MEMORANDUM

Reference: DA20/0509

Subject: Proposed Construction of a Single Storey Building for a Pub and Associated Car Parking Spaces, Stormwater Management and Landscaping Works at Lot 3989 Lakeside Parade Jordan Springs

Drawing Number:
JS-001 G

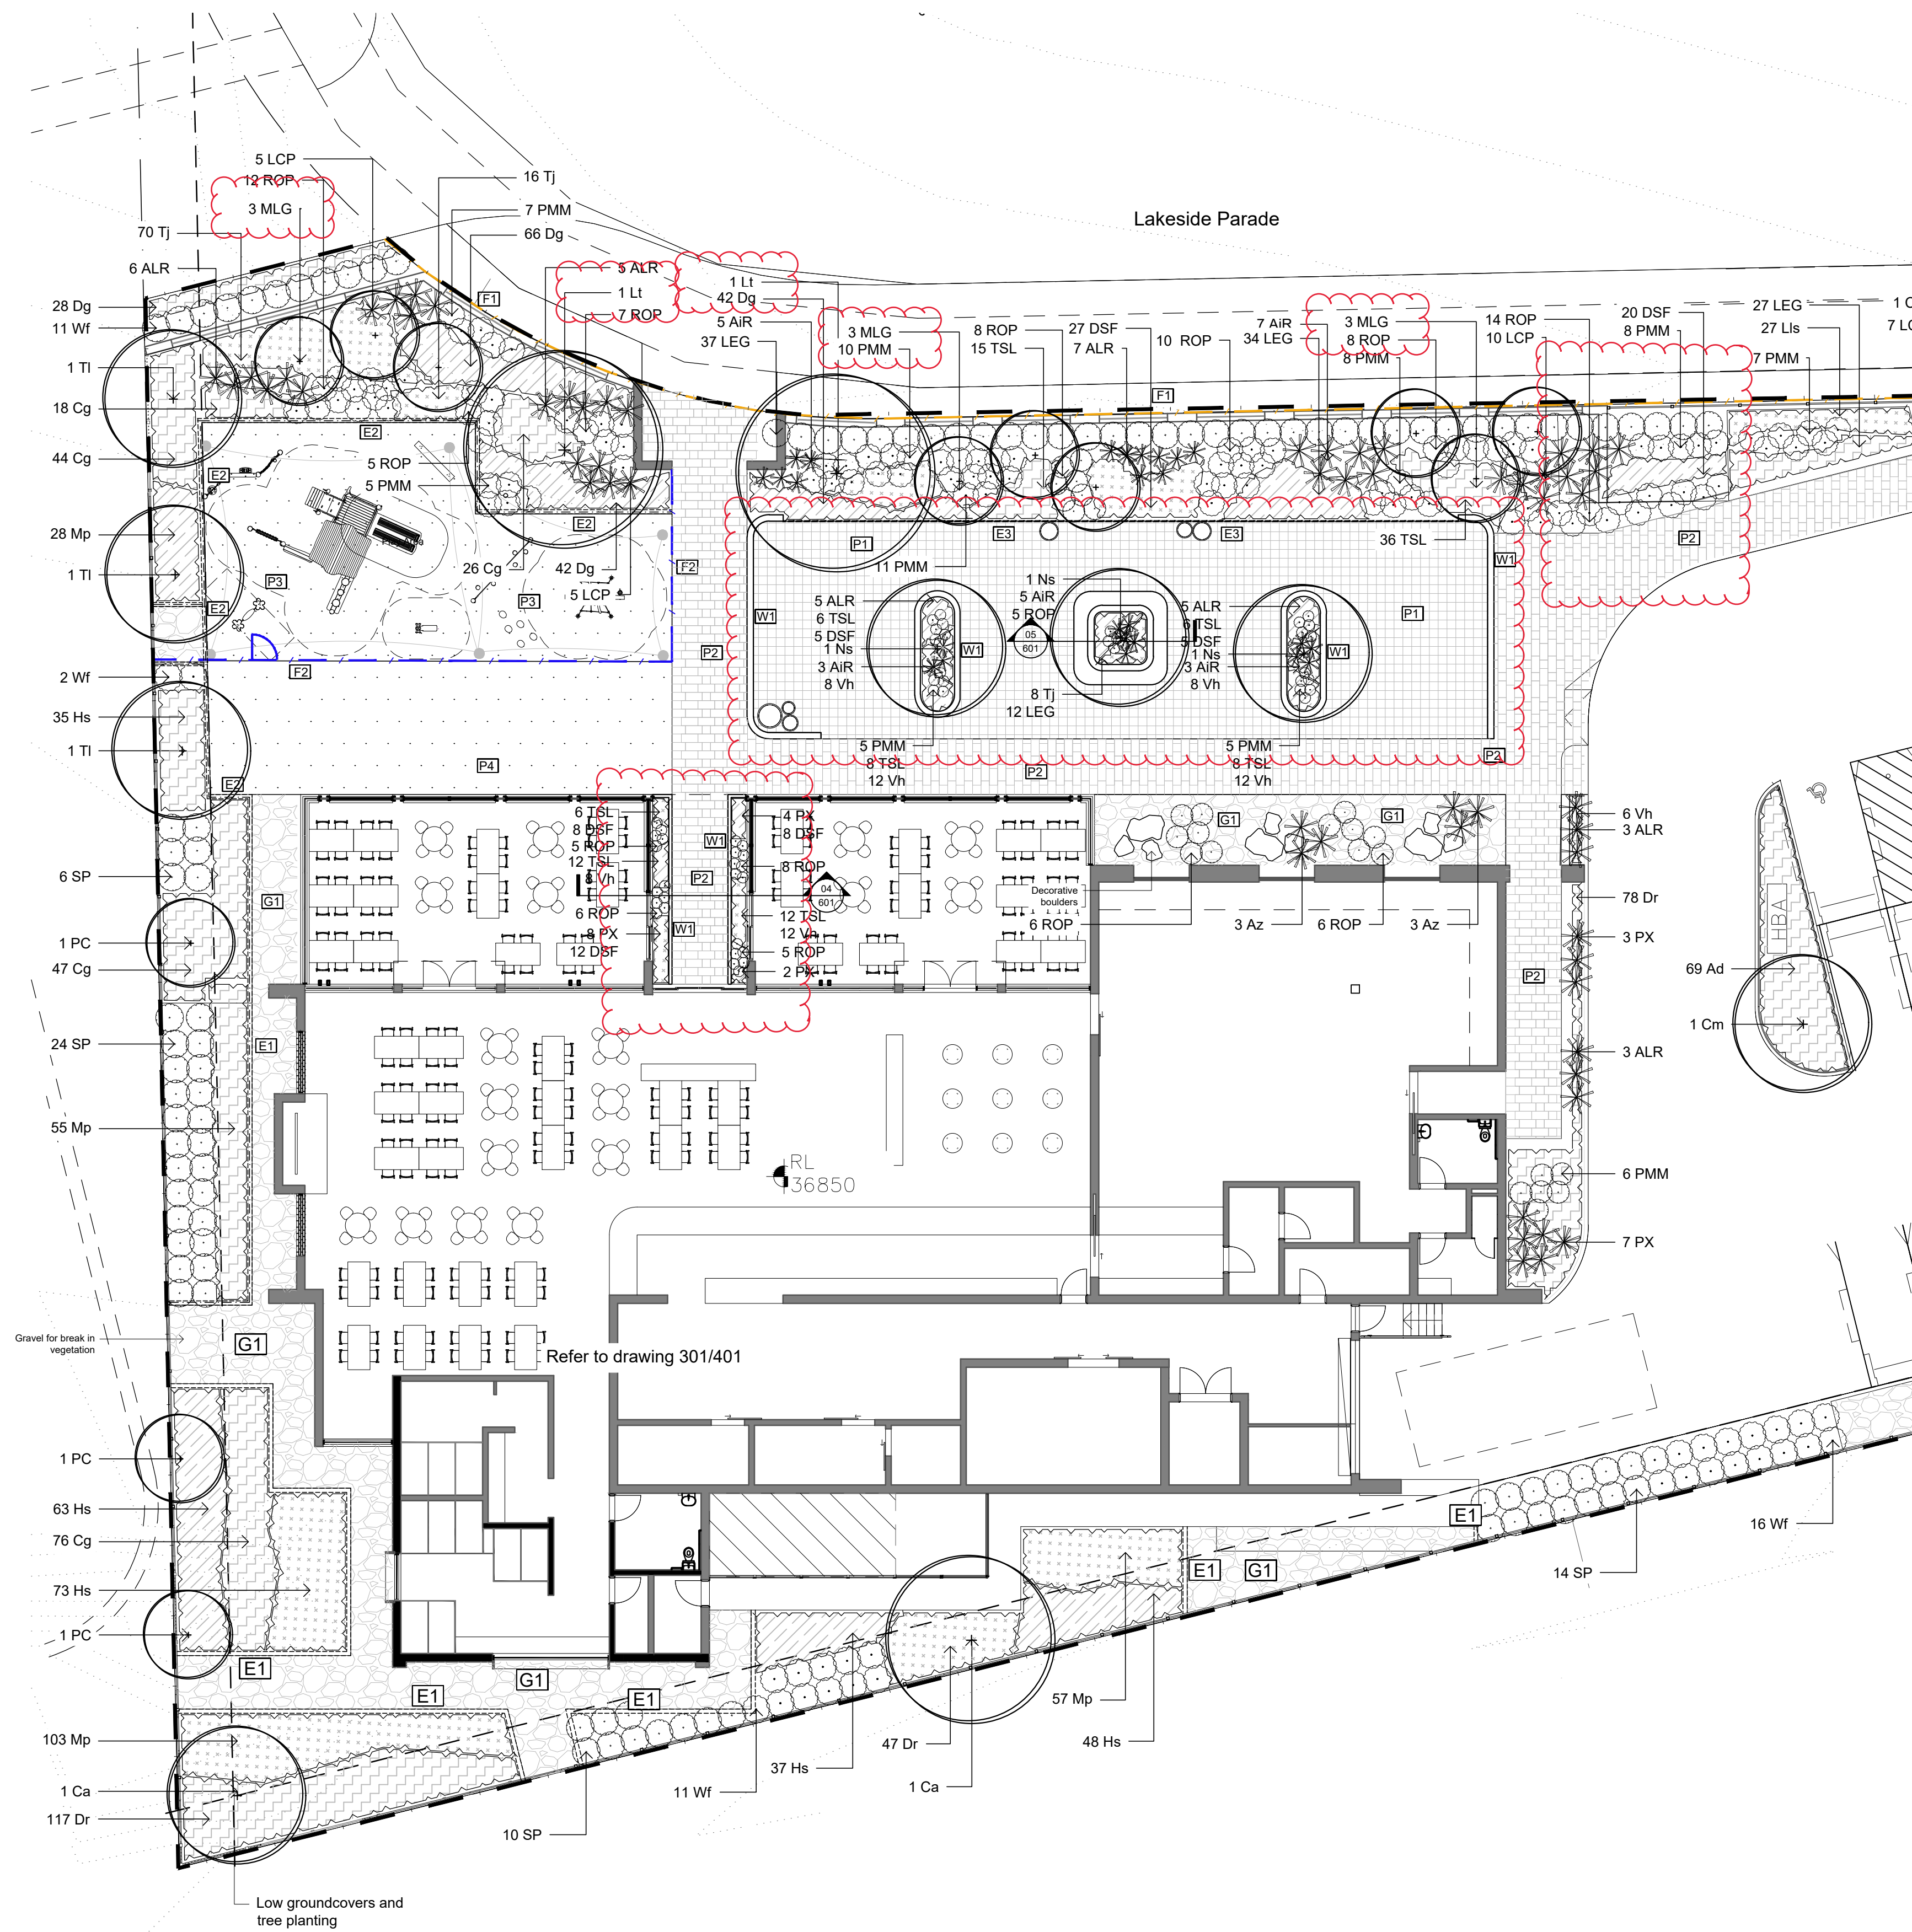
3	<p>The landscape plan has changed in several ways e.g. paving will be used in the beer garden instead of synthetic turf. Tree species have changed. The drawings no longer include a schedule of plant species so we cannot review exactly what has changed. Amended landscape plans that include a schedule are required if they are to be included in the conditions of consent.</p>	<p>An amended landscape plan has been provided that identifies the changes from the previous landscape plan. These changes include:</p> <ul style="list-style-type: none"> - The provision of planter boxes within the beer garden and entry ways; - Deletion of substation; - Kerb line adjusted to allow 3 additional parking spaces; - Provision of pavers instead of synthetic turf within beer garden; and - Minor changes to the plant schedule.
---	--	---

Drawing JS-001-Rev G:

- Minor design refinements to beer garden including planter boxes within beer garden.
- Fill in of previous substation area with planting, after it was confirmed a substation not required for development.
- Planter boxes added to both sides of entry way.
